Subject: Comments on the Notice of Preparation for the Ivanpah-Control Project

LADWP Comments:

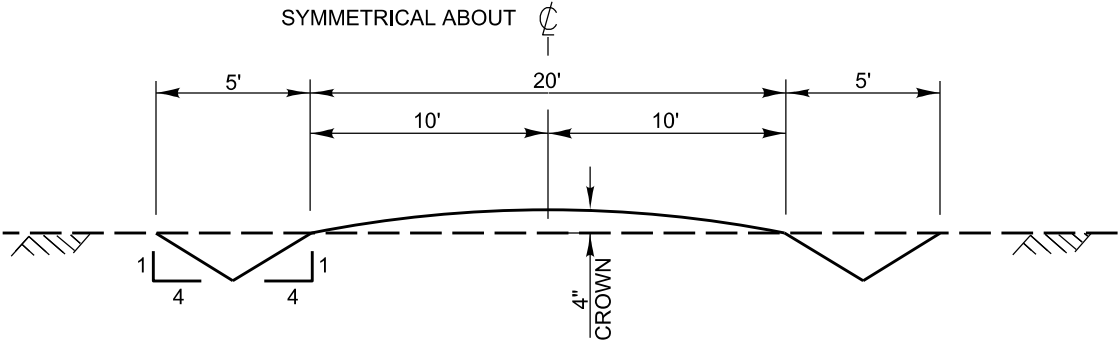
- All ground elevations are to remain unchanged from existing conditions after construction associated with the SCE proposed improvements is completed. Cut and fill

slopes inside LADWP and PDCI TLRW steeper than 2 horizontal to 1 vertical require retaining structures or geotechnical report approval.

]Note: Grading activity resulting in a vertical clearance between the ground and the transmission line conductor elevation less than 35 feet or as noted in the CPUC General Order 95 within the LADWP and PDCI TLRW is unacceptable.
